## **BONNEAU ESTATES SUBDIVISION,** **RESUBDIVISION OF LOT 2**

The purpose of this application is to subdivide an existing lot into two lots of record.

APPLICATION NUMBER 3 DATE January 19, 2006

## DETAIL SITE PLAN

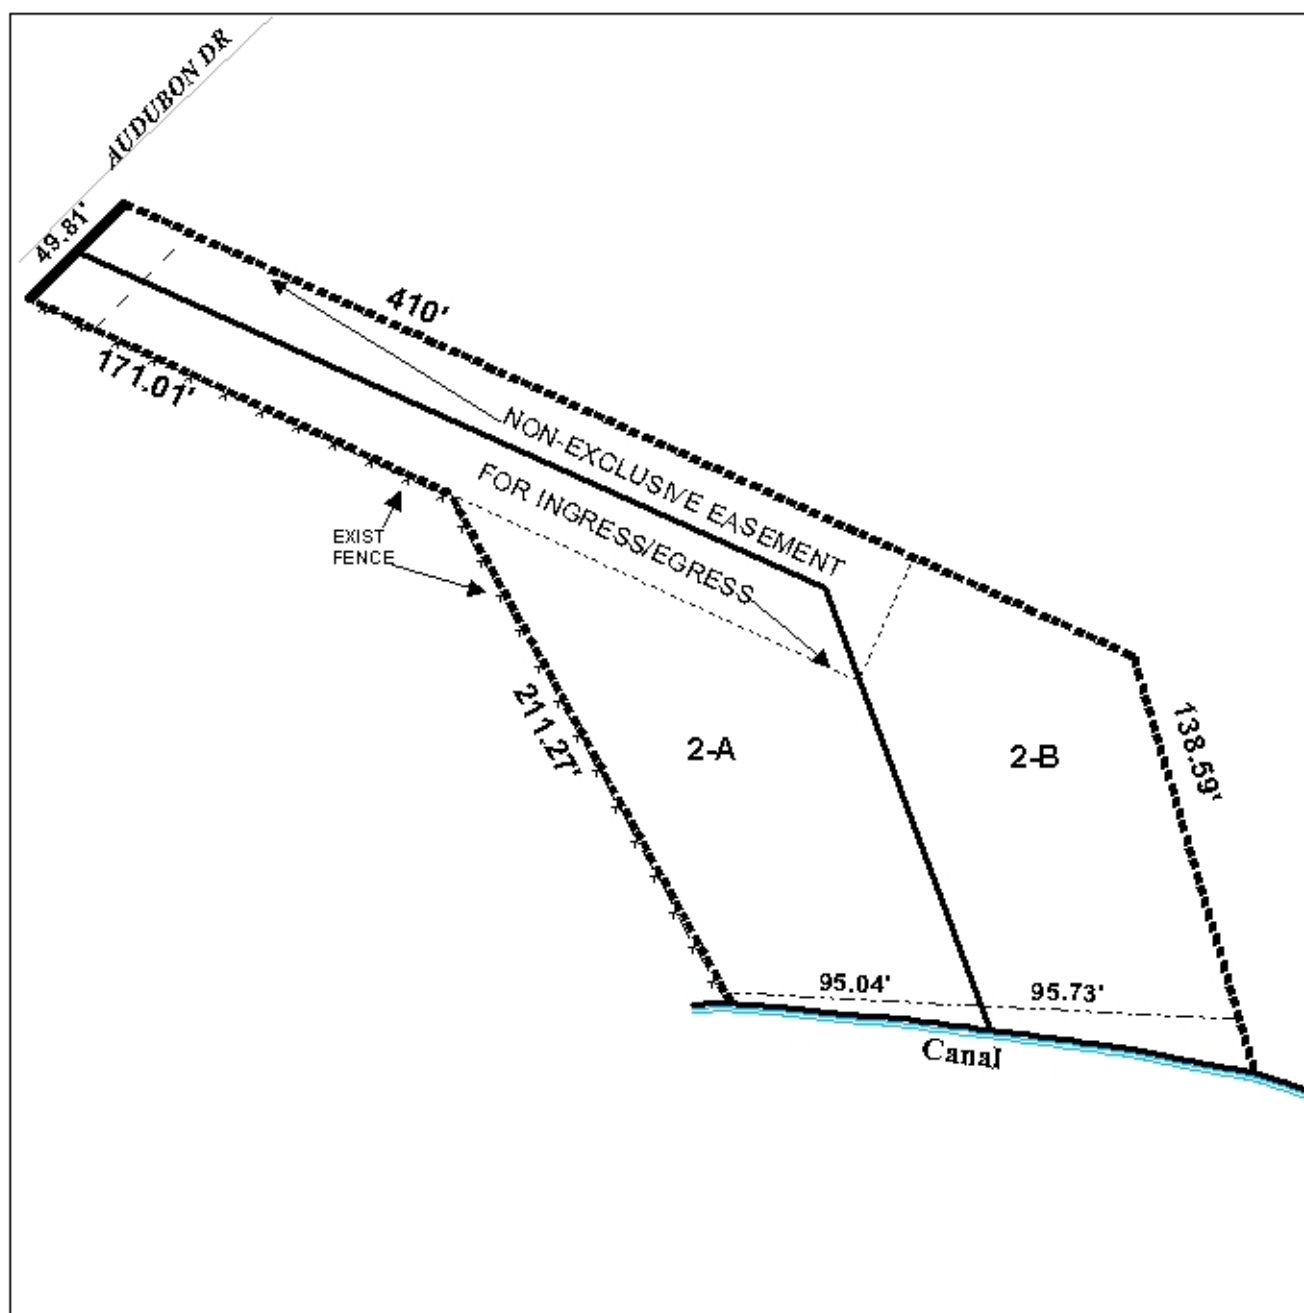
As a means of access management, the placement of a note on the final plat stating that Lots 2-A and 2-B are to share one curb cut. Additionally, there is an easement for ingress and egress.

The site exceeds the maximum width to depth ratio as recommended by the Subdivision Regulations; therefore, a waiver of Section V.D.3., would be required. However, narrow, deep lots are typical along waterways; thus a waiver of V.D.3. would be appropriate.

As indicated on the plat, the 25-foot minimum building setback line is located where the lots are less than 60-feet wide; therefore, the placement of a note on the final plat stating that the 25-foot minimum building setback line is located where the lots are at least 60-feet wide, should be required.

With a waiver of Section V.D.3. (width to depth ratio), the plat will meet the minimum requirements of the Subdivision Regulations and is recommended for Tentative Approval subject to the following conditions: 1) the placement of a note on the final plat stating that Lots 2-A and 2-B are to share one curb cut; 2) the approval of all applicable federal, state and local agencies prior to the issuance of any permits; 3) the placement of a note on the final plat stating that the 25-foot minimum building setback line is located where the lots are at least 60-feet wide; 4) full compliance with Engineering Department comments (*Final plat to specify required minimum finished floor elevations on each lot. Development must comply with all stormwater and flood control ordinances. Any work performed in the right of way will require a right of way permit*); and 5) full compliance with Fire Department comments (*Fire hydrants shall be within 400 foot of all portions of buildings on property. Homes over 3600 square feet may require more than one hydrant*).
